Modification To Improve Input SWR of the DL5K Terminating Load At 54MHz (6Meters)

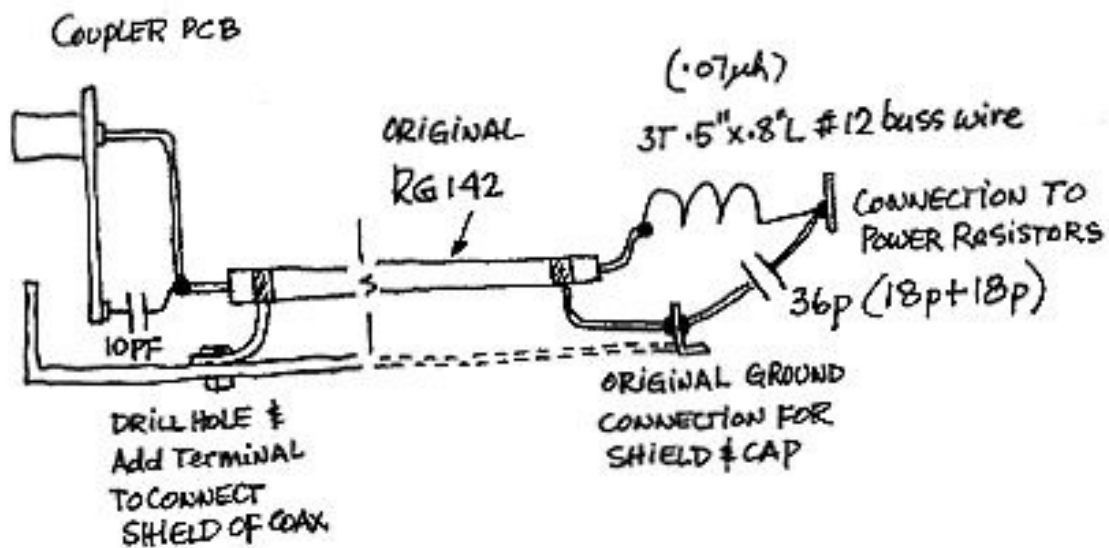
- 1) Remove Blue 18p From Coupler Board
- 2) Add 10p Blue Ceramic Cap
- 3) Remove two Blue Parallel 22p Caps
- 4) Add Two Blue Parallel 18p Caps (For a Value of 36p)
